Document title: Agency Report - Analysis of the Consultation Document for Portugal

Analysis of the Consultation Document on the Gas Transmission Tariff Structure for Portugal

NRA: Entidade Reguladora dos Serviços
Energéticos (ERSE)

13 December 2018

Figure 1. Reference prices as calculated with the proposed RPM and the CWD methodology, €[(kWh/d)/year].

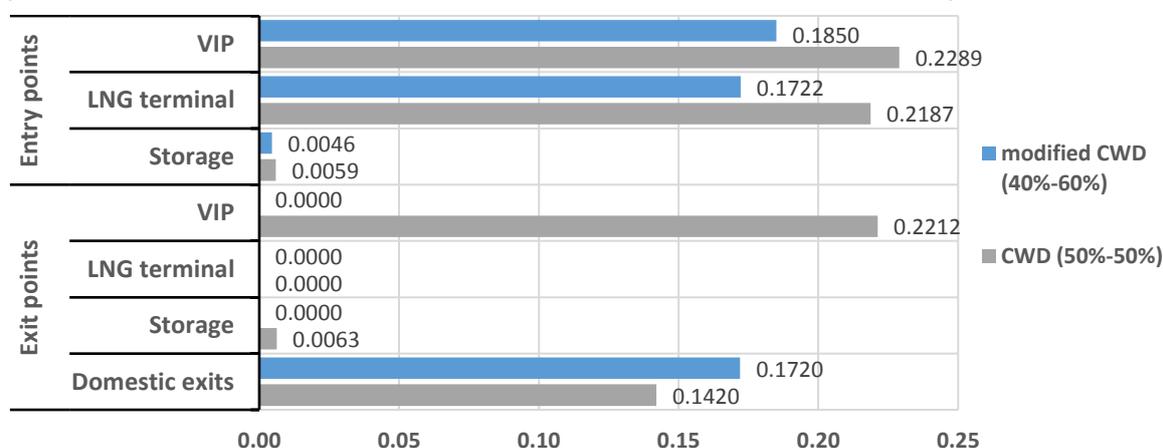
- (24) When looking at the tariffs resulting from the proposed RPM, it is clear that the zero cost driver impacts reference prices. This can be seen when comparing the proposed RPM (labelled as 'modified CWD methodology') with the CWD methodology. These changes are shown in Figure 1 below.

- The proposed RPM results in a zero reference price at the exits to storage, LNG and the VIP. This results from the application of the zero cost driver.

- The proposed RPM results in higher tariffs at domestic exits (+17%) and lower tariffs at entries from LNG (-27%) and from the VIP to Spain (-24%) when compared to the standard CWD methodology. This represents a shift of costs from entries to domestic exits mainly caused by the application of a 40/60 entry exit split different to the 50/50 entry exit split applied in the standard CWD methodology.

Figure 2: VIP Ibérico, REN: Technical capacity, renominations and flows (ordered by renominations) – MWh/day – 2016-2018. Source: ENTSOG Transparency Platform

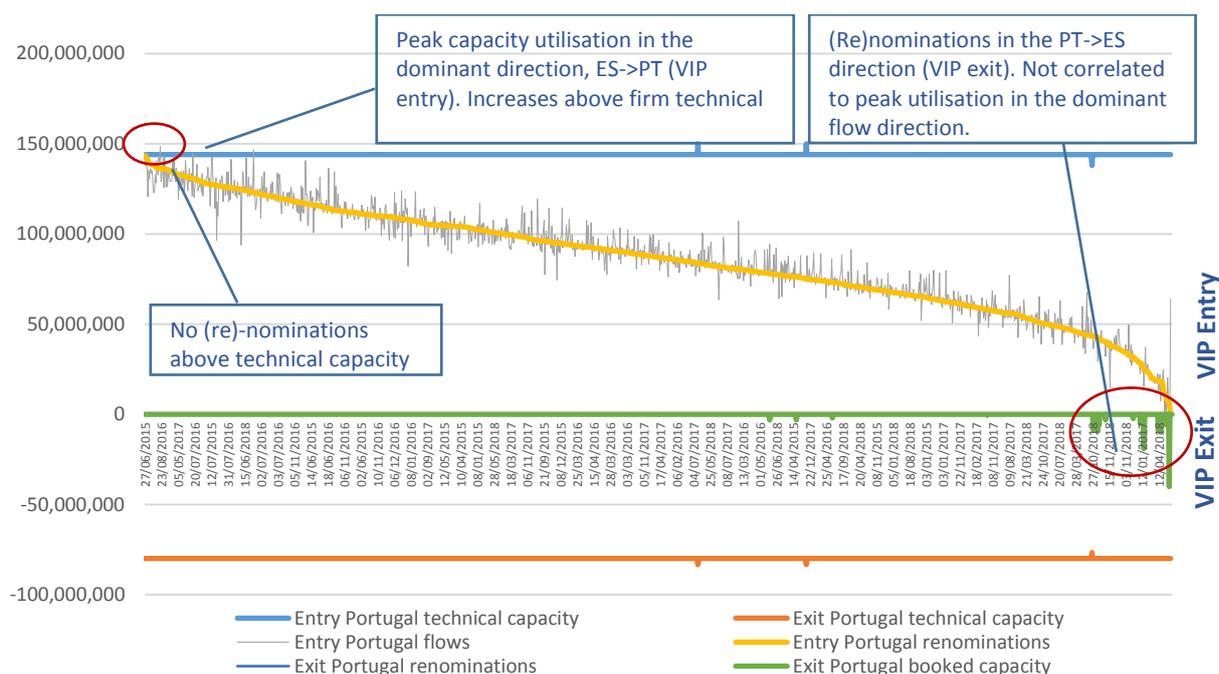
- (28) Second, the zero tariff that ERSE proposes to alleviate potential congestion does not seem to be the adequate instrument to address congestion. The data available at the ENTSOG TP shows that capacity bookings in the exit direction only occur at times of low utilisation in the dominant entry direction; they do not coincide with peak flows in the dominant direction (see Figure 2 and Table 5). In the Agency’s view, no correlation between exit and peak entry booking exists and thus this cannot justify using the former to decrease the latter¹⁰. A zero tariff at the VIP does not lead to avoiding potential investments triggered by peak utilisation in the entry direction. Bookings in the exit direction serve to reduce flows when the utilisation rate at the IP is at its lowest.

- (29) The Agency also points out that exit bookings are likely to result in physical flows in the exit direction. If exit bookings happen at times of low entry utilisation, exit bookings might exceed entry bookings. ERSE commented in a clarification to the Agency¹¹ that, should the flow direction change as a result of the use of zero capacity tariffs at the VIP exit, the RPM would have to be reconsidered. Based on the data from the ENTSOG TP, net physical flows in the PT->ES direction already have happened on 31 October 2018¹².
